**From:** Rick Dube [Rickdube@mainelytrusses.com]  
**Sent:** Monday, July 28, 2003 9:45 AM  
**To:** rderice@maine.rr.com  
**Subject:** RE: Roof trusses with AC Unit.PDF

**From:** Rob DeRice [mailto:rderice@maine.rr.com]  
**Sent:** Friday, July 25, 2003 4:59 PM  
**To:** Rick Dube  
**Subject:** Roof trusses with AC Unit.PDF

Job 017879	Truss T01-LD2	Truss Type COMMON	Qty 25	Ply 1	Job Reference (optional)
---------------	------------------	----------------------	-----------	----------	--------------------------

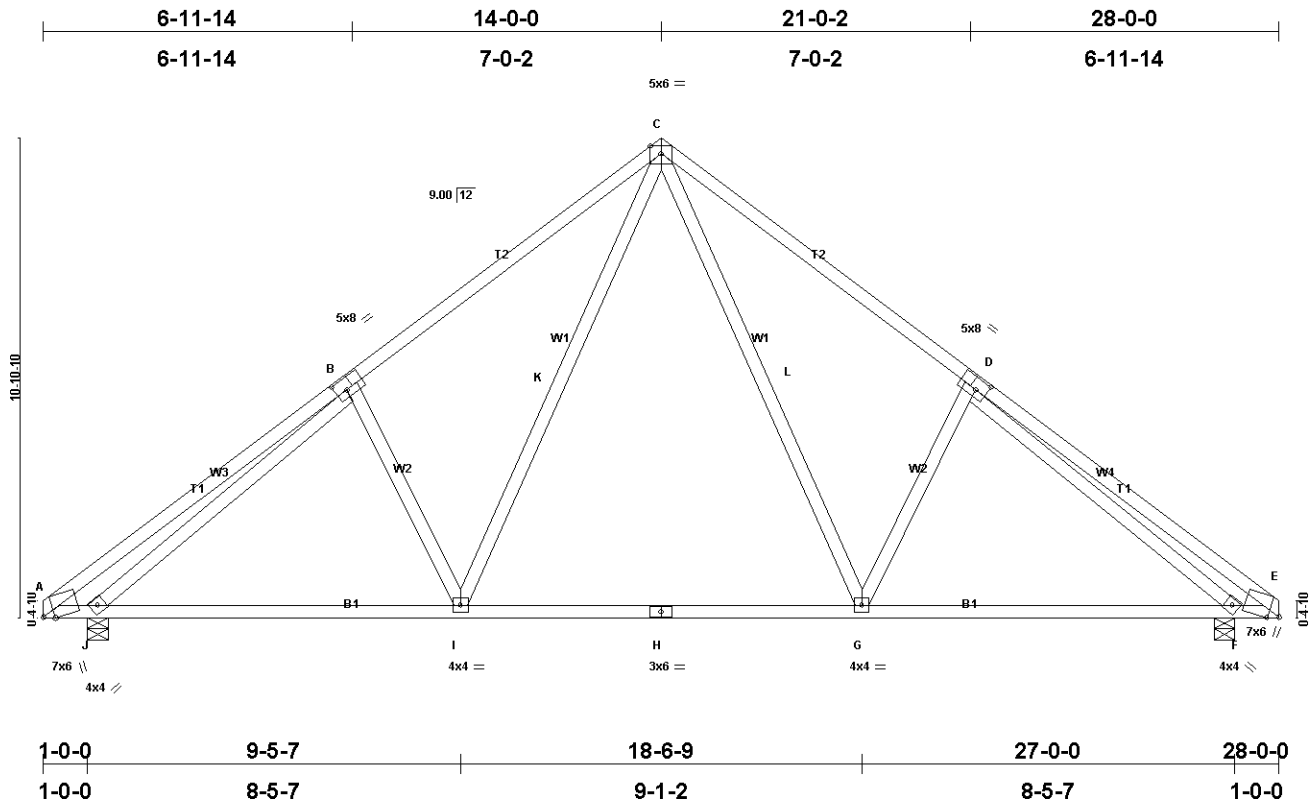
Rick, Attached is the sketch. It is in PDF format so I assume you can open it. Bob DeRice

Bob,  
Web member W1 loaded with a 50 # concentrated load at locations K and L, with no changes to the truss.  
This configuration for your AC unit is just fine.
